Addendum No.: 2

Date Of Addendum: June 12, 2019

Enfield Armory Kitchen and Latrine Renovations  
1635 King Street, Enfield CT  
BI – Q – 672C

The following clarifications are applicable to drawings and specifications for the project referenced above.

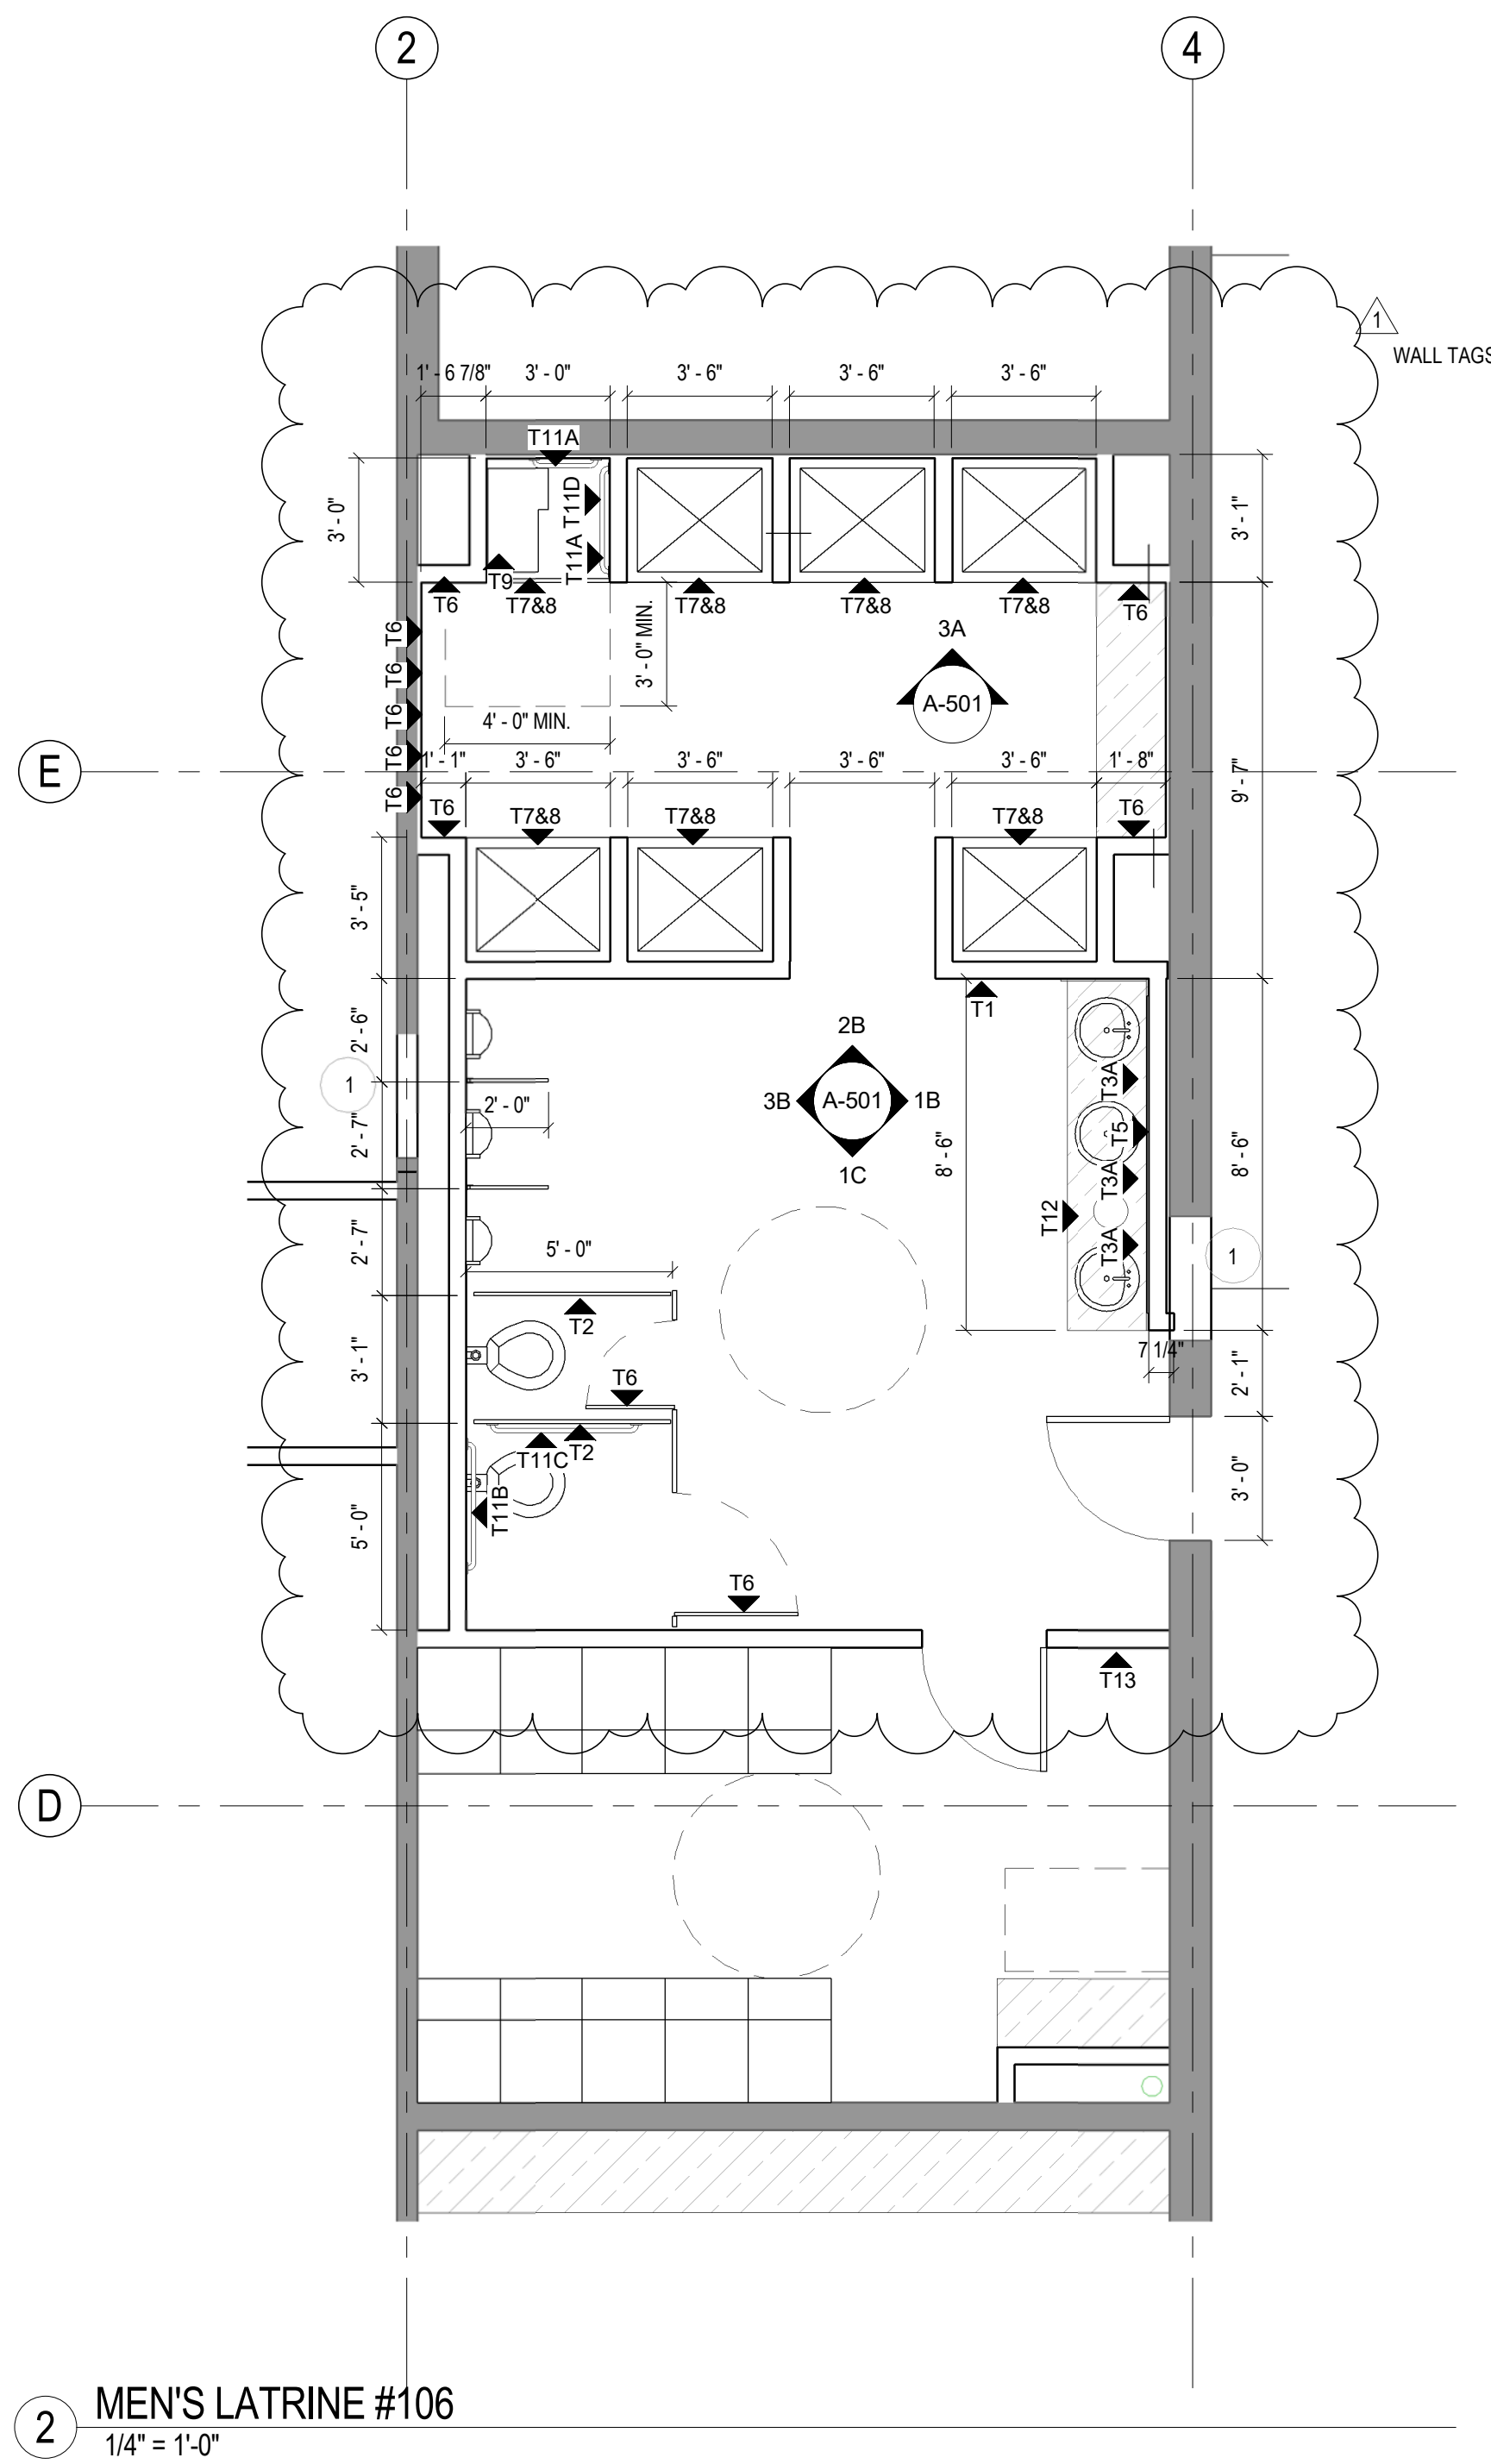
RFI Question: Can the floor plan be labeled with the desired wall types as they are currently not labeled?

RFI Question: Please confirm that note #9 on drawing A-101 only pertains to the existing walls in the contract/work area and not throughout the entire building.

RFI Question: On drawing A-101 there are several areas where new walls are shown, but no wall types are given aside from the interior walls of the kitchen. Can an updated drawing be sent out with the applicable wall types?

RFI Question: The Drawings say 'FULL HEIGHT (FIT AROUND STRUCTURE AND MEP ITEMS ABOVE)' The Specs call for Ceilings in several places - 2.04 WIRE MESH CEILINGS; 2.05 FABRICATION C. Wire Mesh Ceilings; and 3.01 ERECTION B. Wire Mesh Ceilings. -Please advise on ceilings or full height options.

RFI Question: The Drawings say 'NEW HASP AND PAD-LOCKED STEEL WOVEN WIRE CAGE STORAGE' The Specs call for Cylinder Lock: Mortise type with manufacturer's standard cylinder operated by key outside and recessed knob inside. -Please advise on door lock requirements.

ID3A Response: A-101 and A-301 reissued with wall types shown

ID3A Response: Note does not apply to Area Not in Contract

ID3A Response: A101 & A301 reissued with wall types shown

ID3A Response: Please provide full height cages as described in Floor Plan Key Notes #3 on Sheet A-101. Spec section 2.04 Wire Mesh Ceilings deleted in Item #15 above

ID3A Response: Please provide new hasp and pad lock as described in Floor Plan Key Notes #3 on Sheet A-101, and revised specification noted in Item #14 above

2C SHOWER SECTION  
3" = 1'-0"

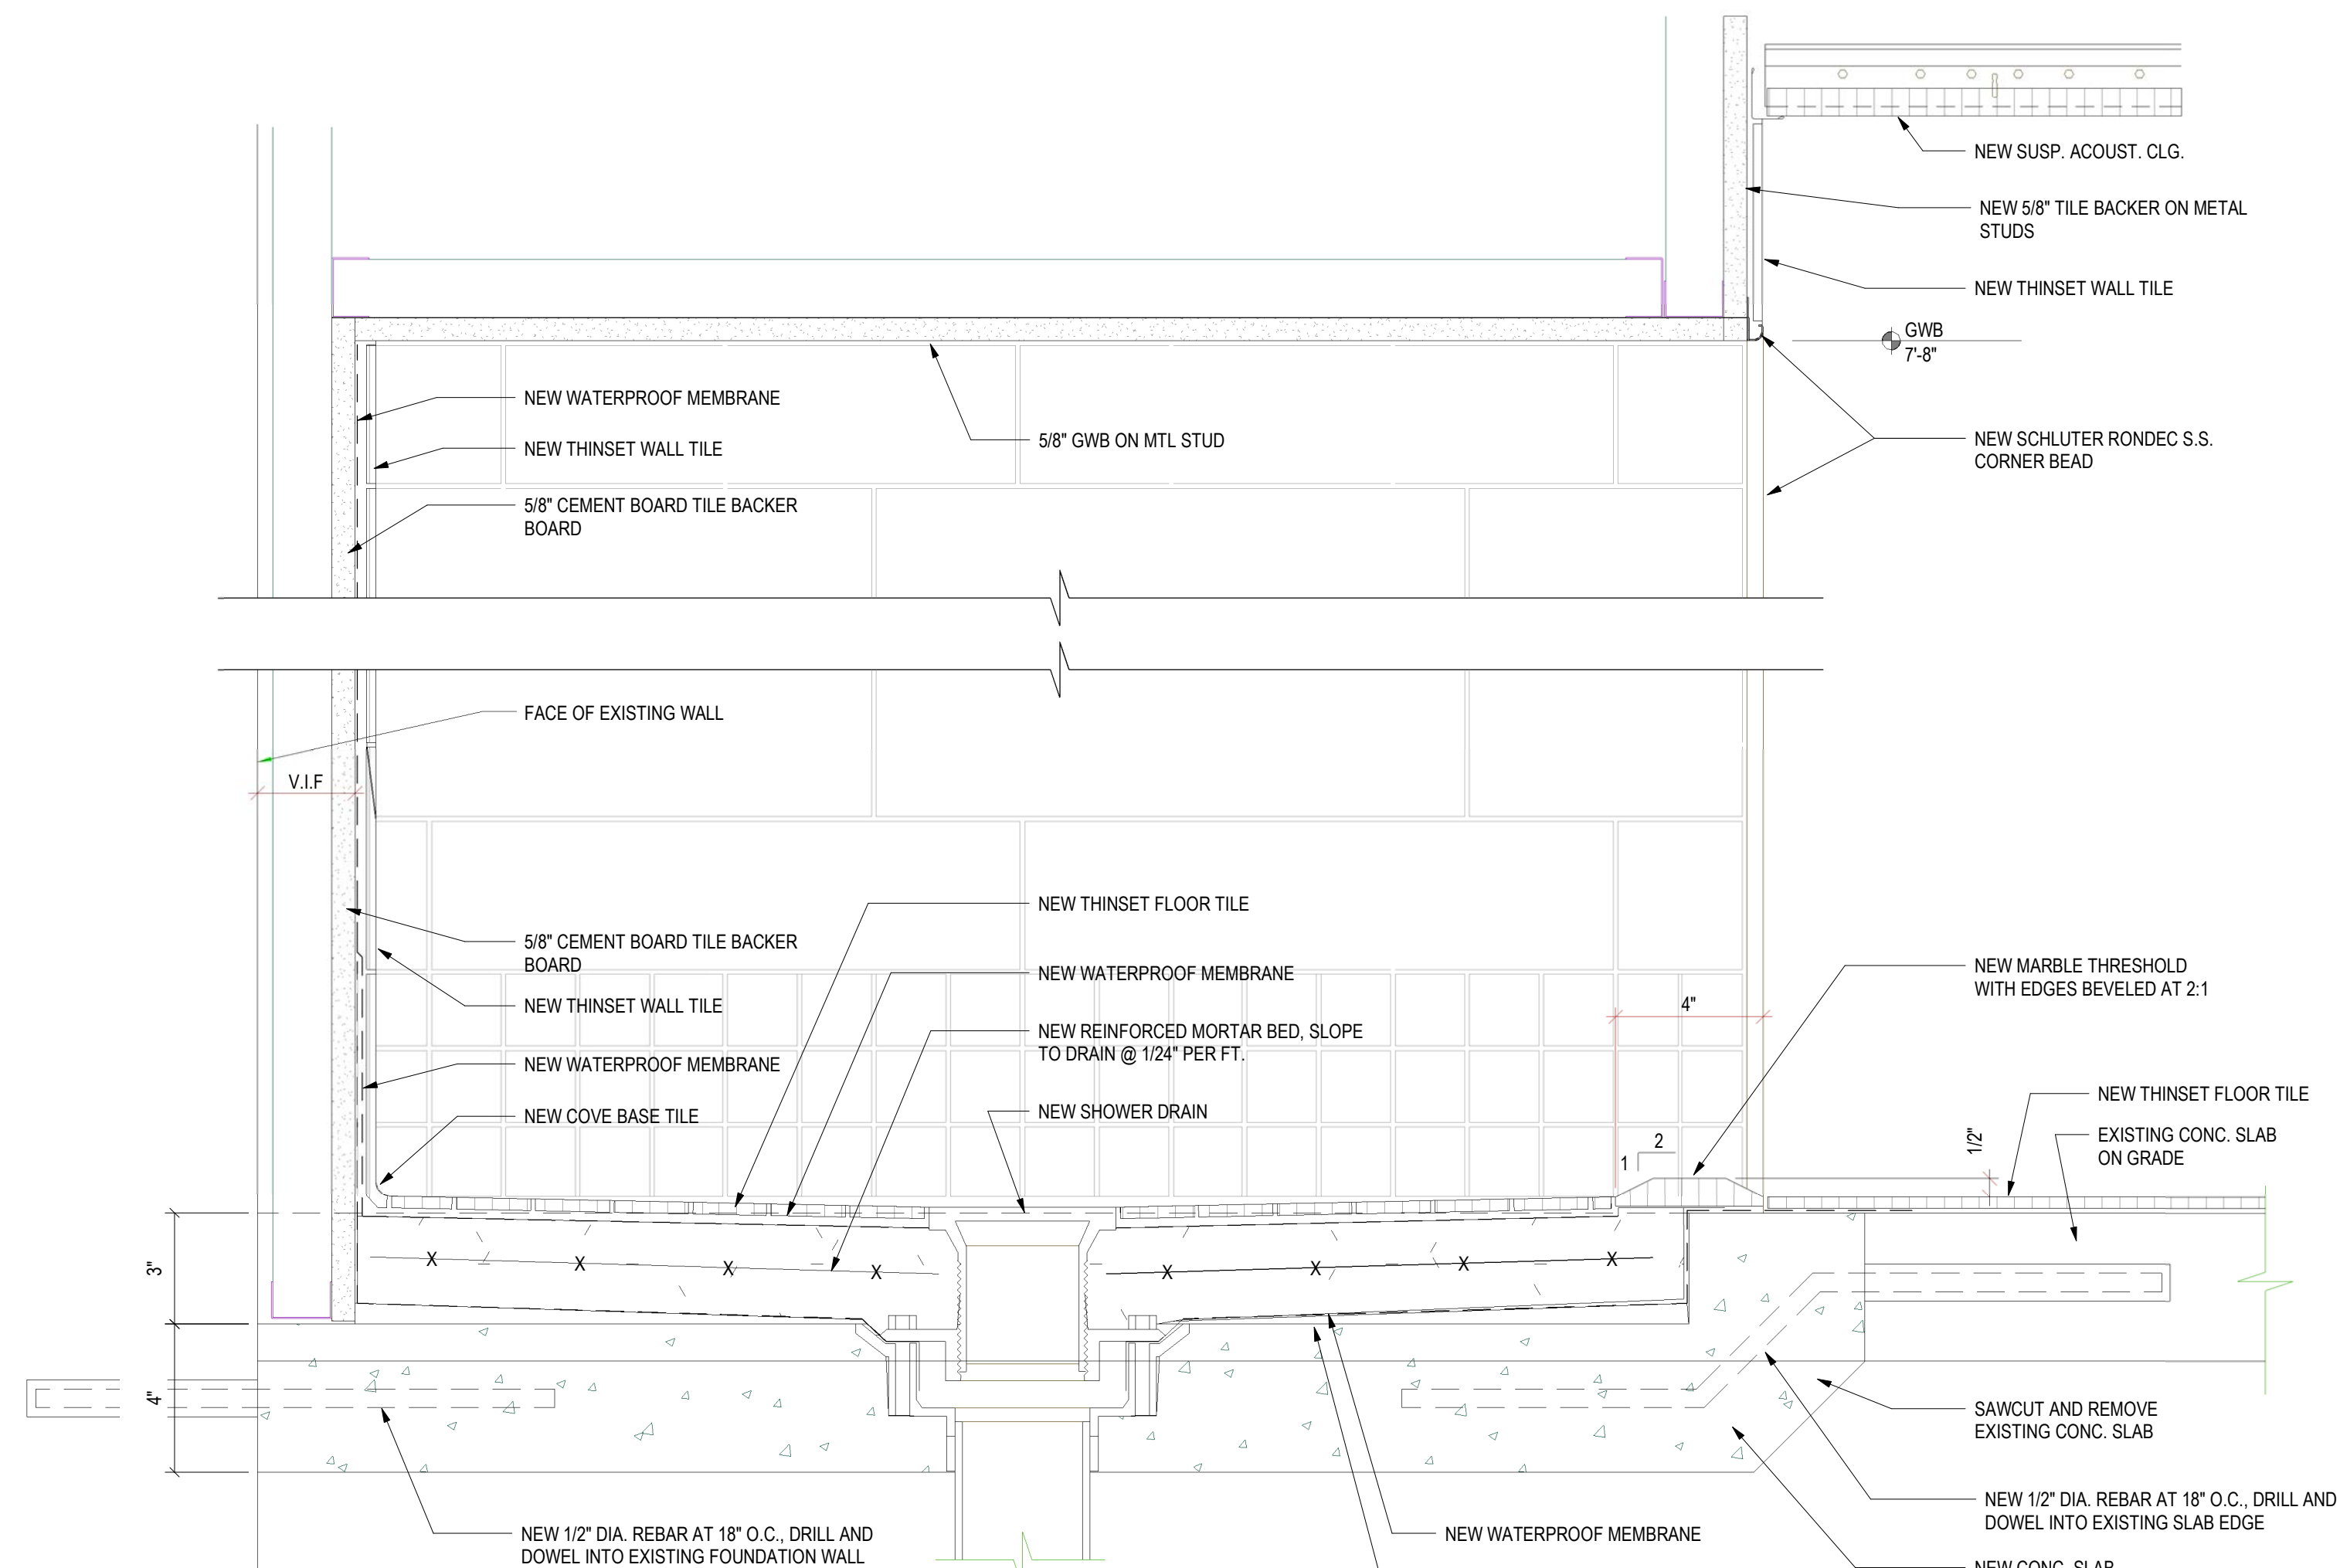
RFI Question: On drawing A-101 in the Men's and Women's bathrooms at the showers there looks to be a callout to detail 2C on A601, but this detail does not exist. What detail is applicable for shower walls?

ID3A Response: Refer to detail 2C / A602
